**KFO objection to
Notice of Intention to Designate
Porcupine Shelf and Southern Canyons SACs**

**Edward Farrell
Killybegs Fishermen's Organisation
Designated Areas Appeals Advisory Board (DAAAB)
Friday 14 March 2025**

KFO Appeal Report Outline

6b. Proposed Porcupine Shelf SAC – presented evidence

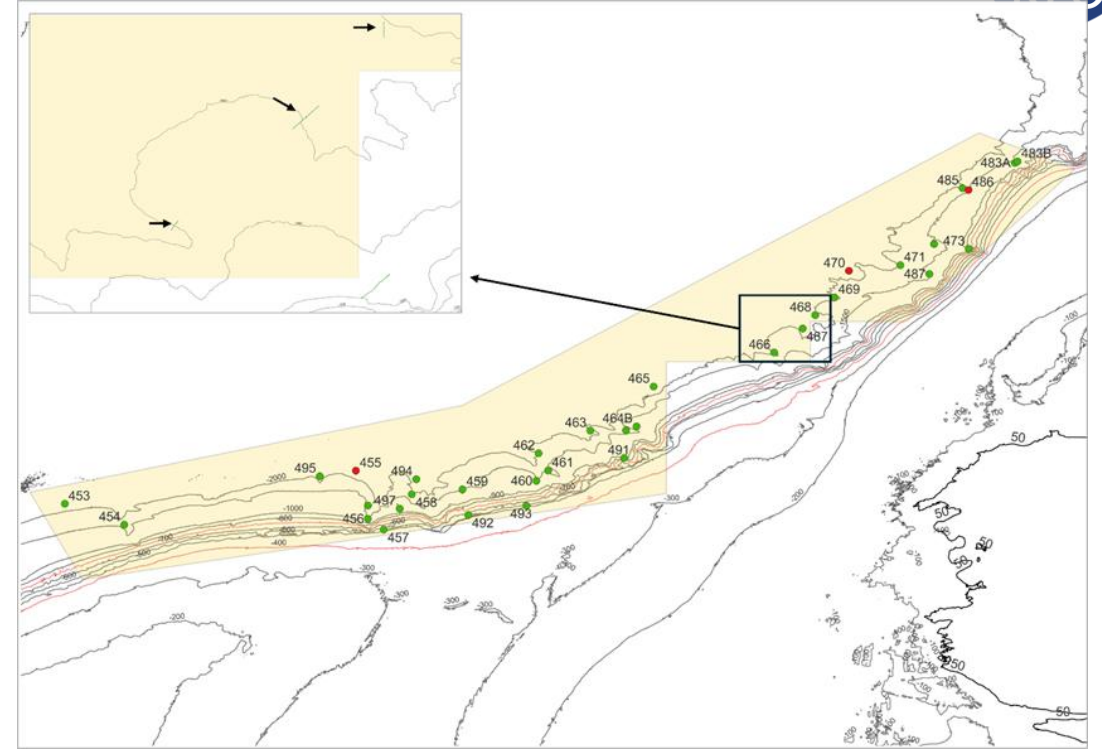
- 2017 SeaRover survey (www.searover.ie)
- 34/50 ROV stations in SAC area
- Transects pre-selected to maximise *Reef*
- No transects started <500m depth
- Three transects 500-700m zone
- Shallowest evidence for *Reef* 463m
- Total estimated observed reef 18.89km²
- Majority geogenic reef
 - outcrops, rocks, boulders and cobbles
- % observed *Reef* in proposed SAC **0.0013%**

6b. Proposed Porcupine Shelf SAC – Additional Evidence

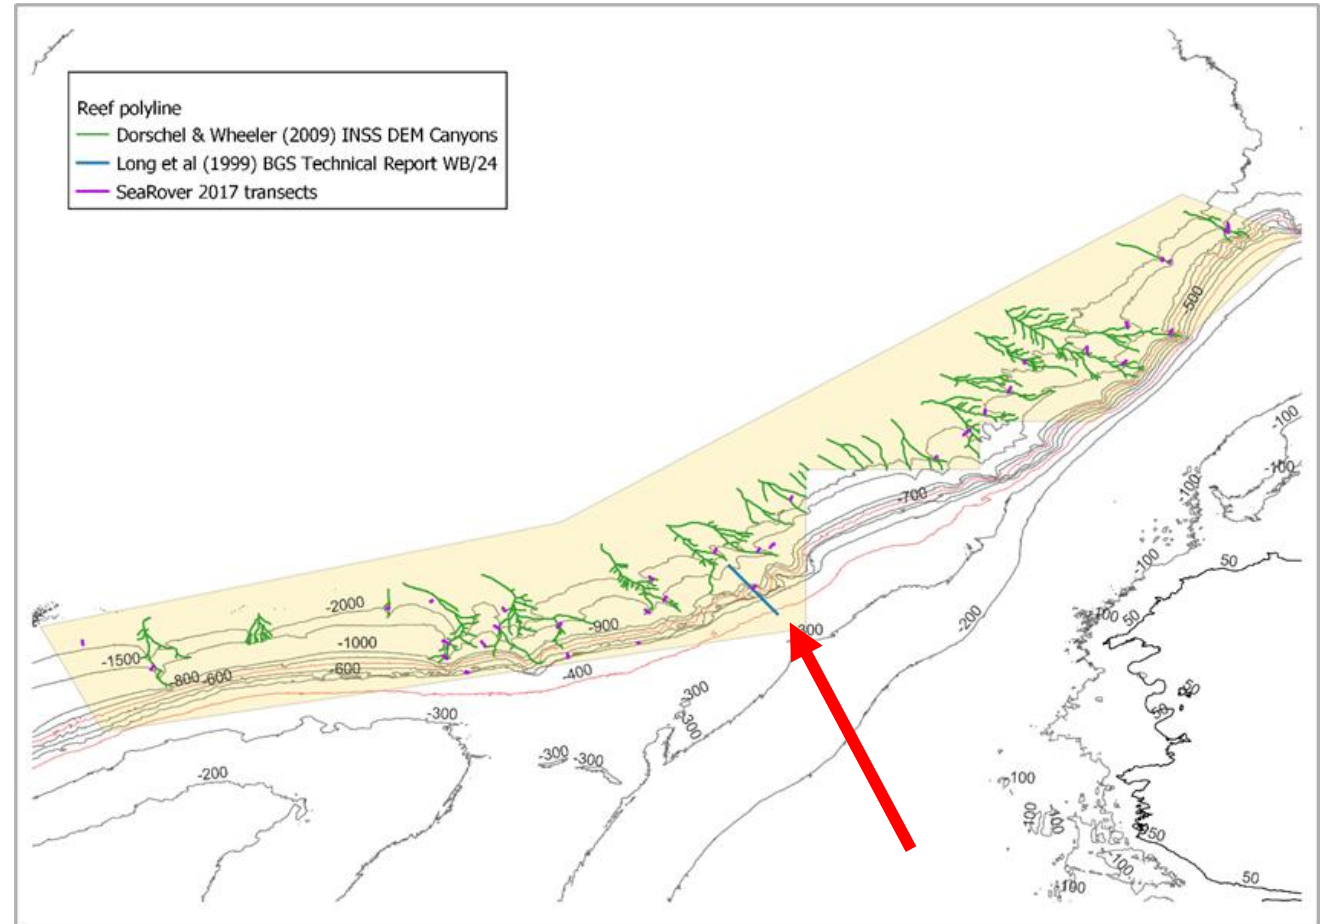
- “15,000 records of reef habitat”
- Reef Polyline, Points, Polygons
- **Reef Polyline** – 3 sources
 - 1) SeaRover transects
 - 2) Dorschel & Wheeler (2009)
 - Modelled canyon topography
 - 3) Long et al (1999)
 - Single 21.5 km track.
- Track is basis for shallow extension
- Le Danois, 1948
 - Sampling transect
 - Not a point occurrence

6b. Proposed Porcupine Shelf SAC – Additional Evidence

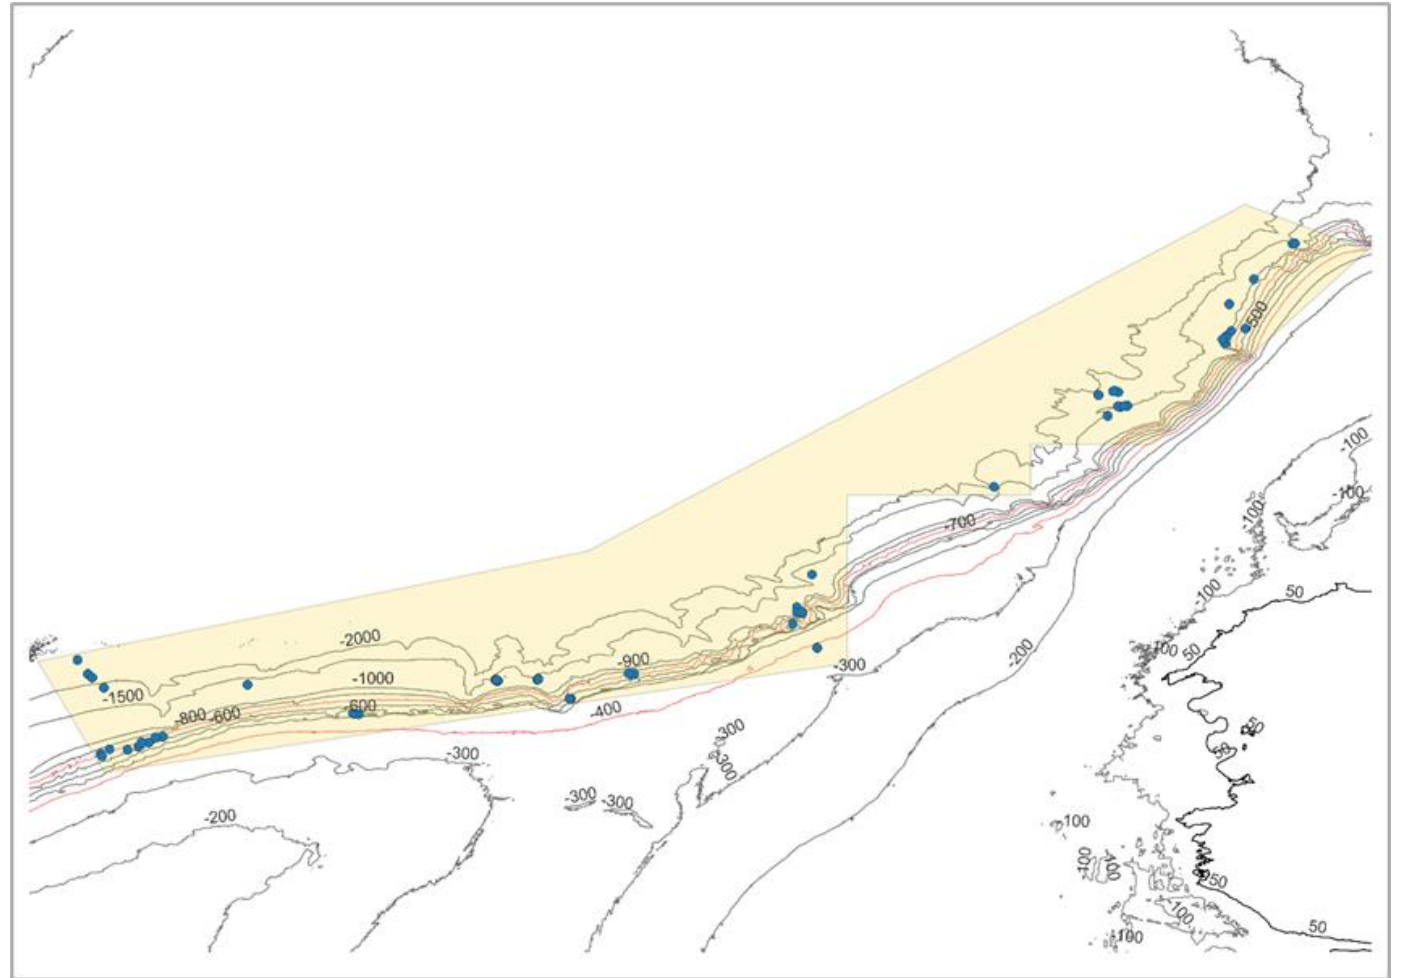
- Reef Points – 29 sources
- Majority deeper than 800m
- 1 record in 500-600m zone
- 2 records <400m
 - c. 3m apart
 - Same as Reef Polyline
 - Duplicated records
 - records <400m incorrect
 - 700m midpoint of transect
- Multiple other erroneous and duplicated records

6b. Proposed Porcupine Shelf SAC – Additional Evidence

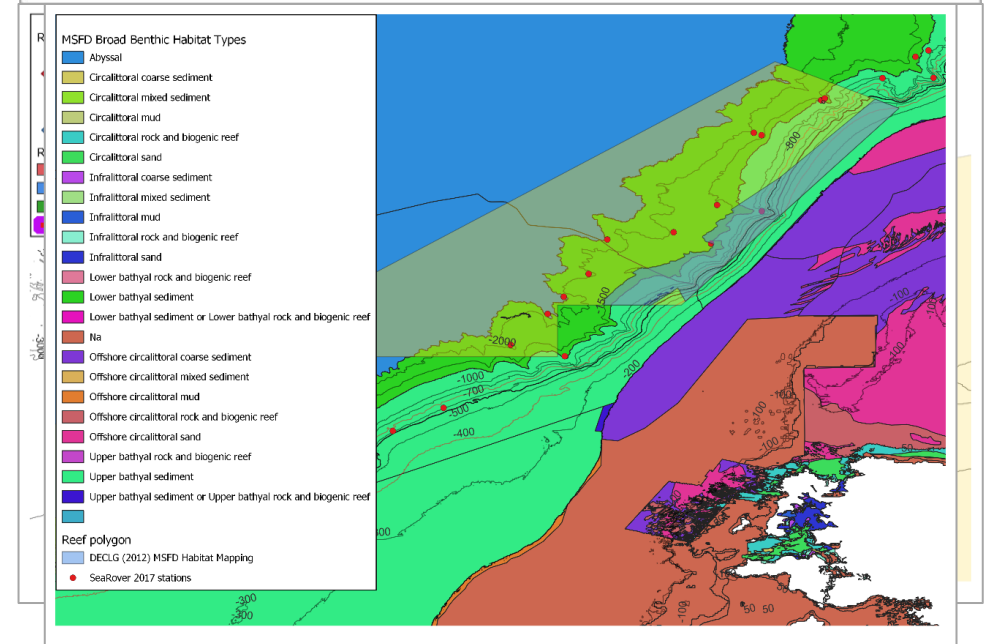
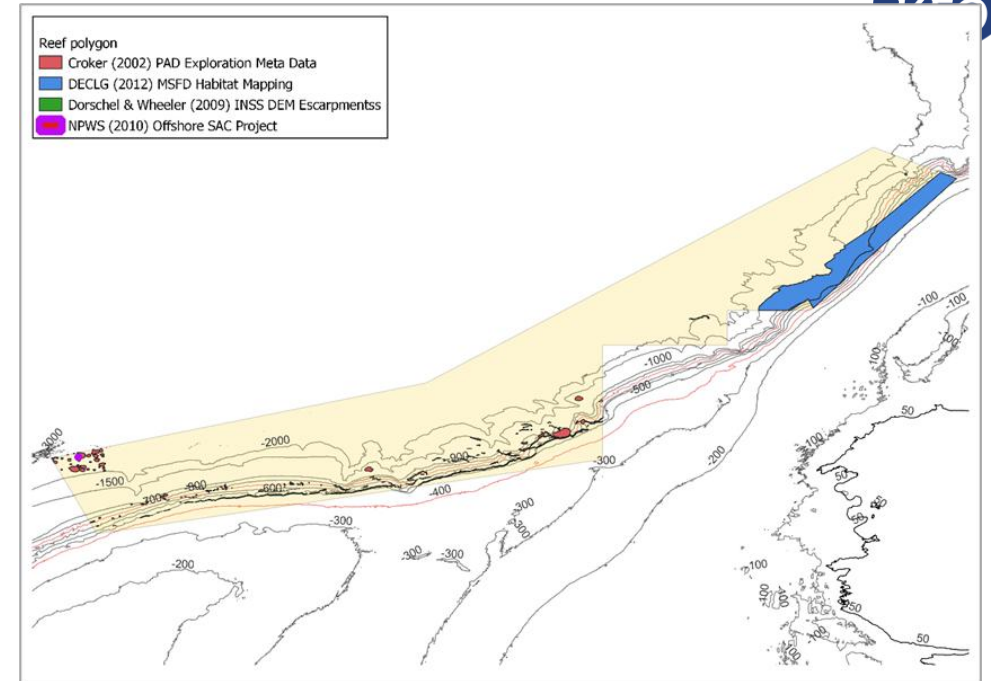
- Reef polygon – 4 sources
- *Croker (2002)* and *NPWS (2010)*
 - Duplication of records
- *INSS DEM Escarpments* – modelled topography
 - Long cliff/steep slope
 - Not evidence of Reef habitat
- *DECLG (2012) - MSFD Habitat Mapping*
 - Metadata = geogenic rock
 - MSFD Benthic Habitat = muddy sand/sandy mud
 - Deeper polygon = small % Reef Habitat
 - Shallower polygon = no basis for inclusion

6b. Proposed Porcupine Shelf SAC – Biased analysis

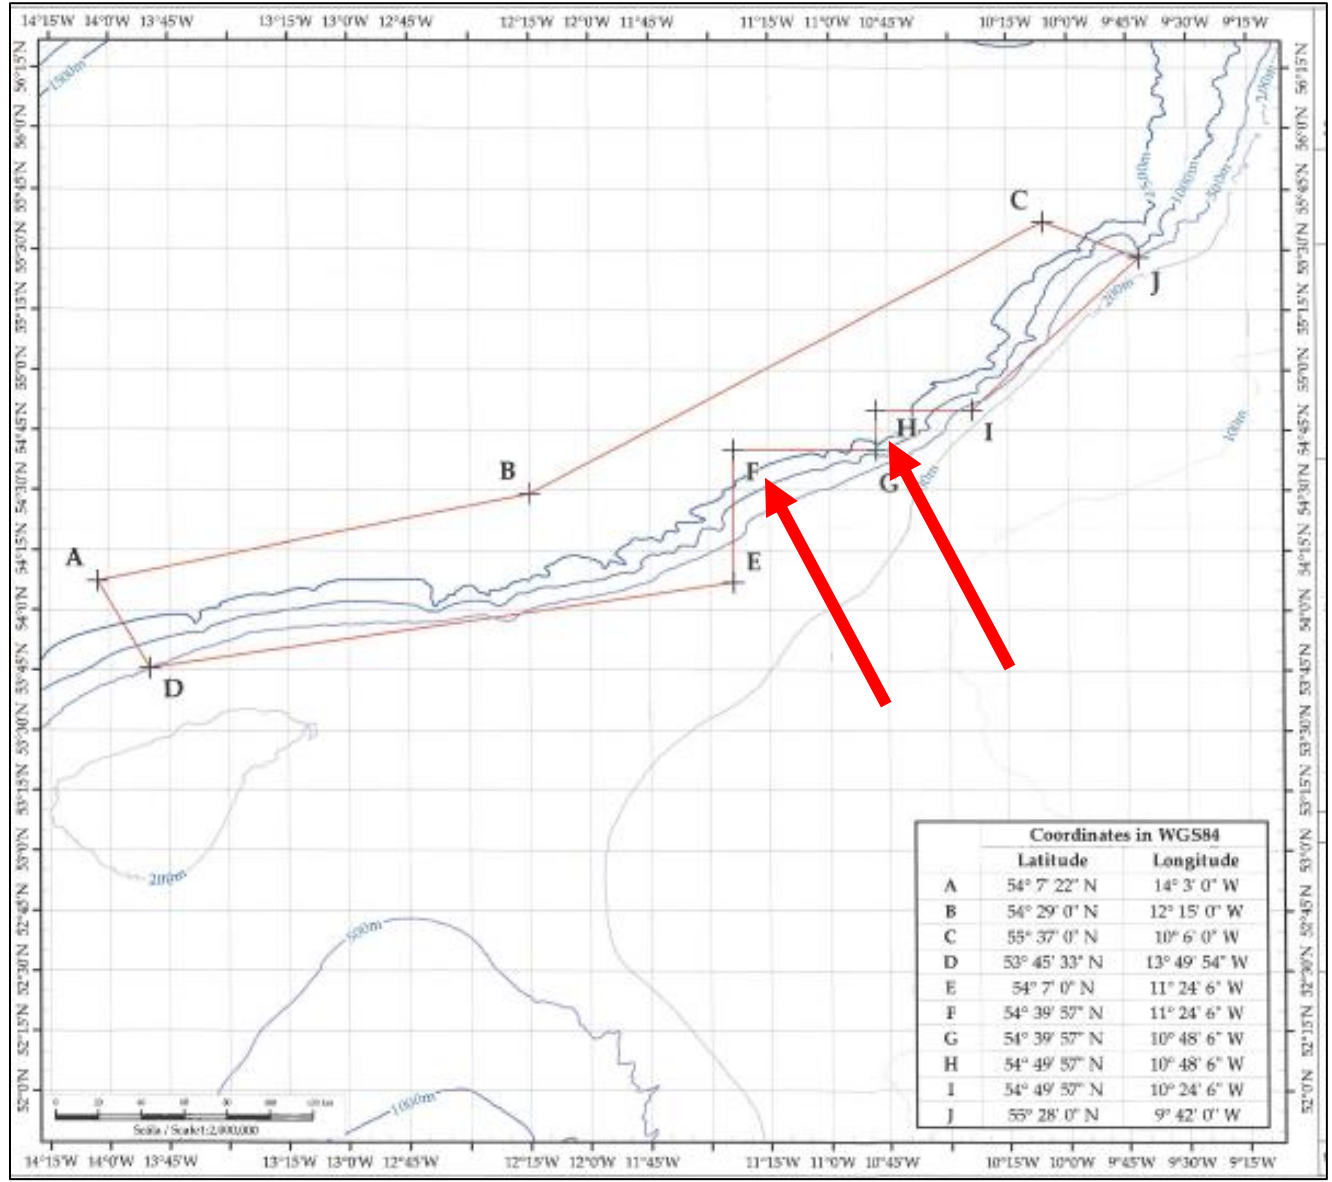
- Large cut out areas in SAC outline
- No explanation provided
- Error in KFO appeal report
 - 3 SeaRover transects within cutouts
 - Reef observed in all 3 transects
- No other data included in these areas
- Non-renewable energy production and exploration licences issued by DECC
- Delineation of the SAC tailored to avoid the EL3/19 and EL4/19 areas

6c. Proposed Southern Canyons SAC – Presented Evidence

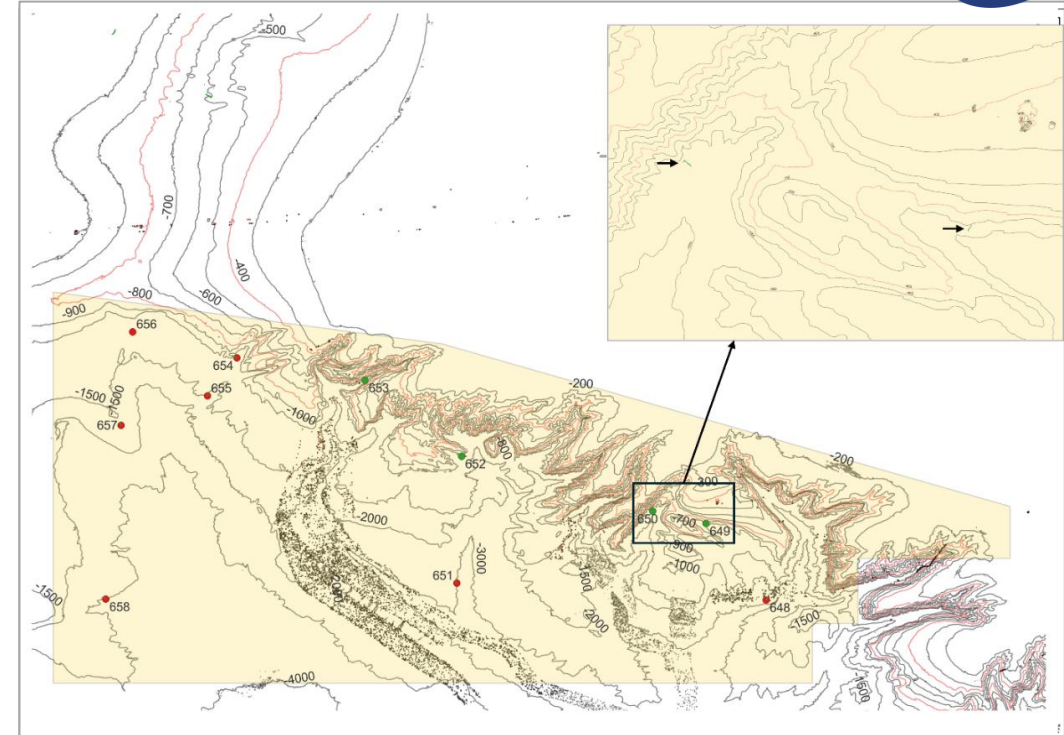
- 2019 SeaRover survey (www.searover.ie)
- Transects pre-selected to maximise *Reef*
- 11/52 ROV stations in SAC area
- No transects started <900m depth
- 7/11 transects had no *Reef* (geo or biogenic)
- 9/11 had no biogenic *Reef*
- 2 transects with biogenic *Reef* had <10% occurrence
- Area dominated by soft sediment habitats
- Total estimated observed reef 0.24km²
- % observed *Reef* in proposed SAC **0.000017%**

6c. Proposed Southern Canyons SAC – Additional Evidence

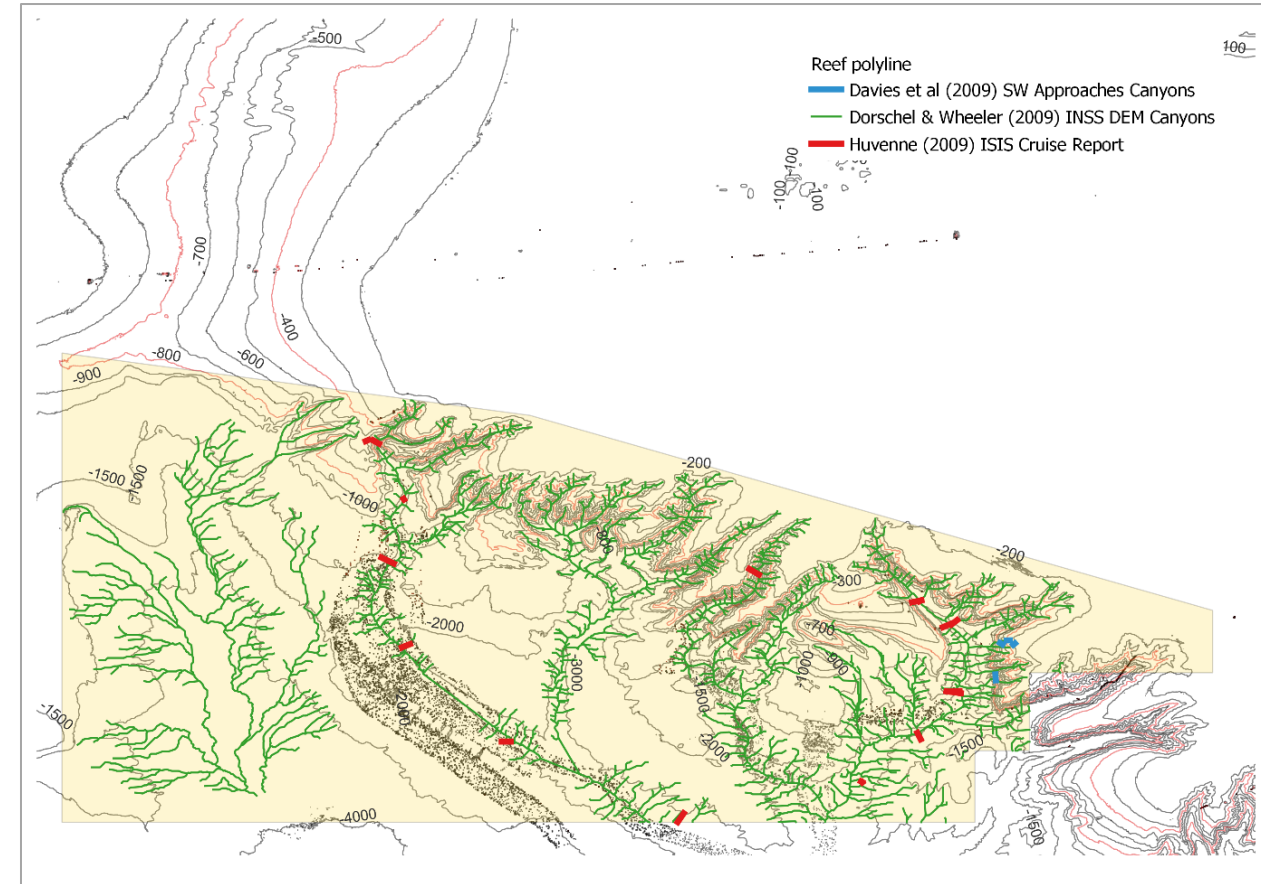
- “15,000 records of reef habitat”
- Reef Polyline, Points, Polygons
- **Reef Polyline** – 3 sources
 - Dorschel & Wheeler (2009)
 - Modelled canyon topography
 - Davies *et al.* 2009
 - MESH Canyon Survey 2007 – camera
 - No Reef in shallowest tow (280-300m)
 - Rock ledge in 350-440m tow
 - Some bedrock and coral in deep tows
 - Huvenne (2009)
 - 2009 ROV survey
 - Shallowest transect at 547m
 - Evidence for Reef not clear as not mentioned in cruise report
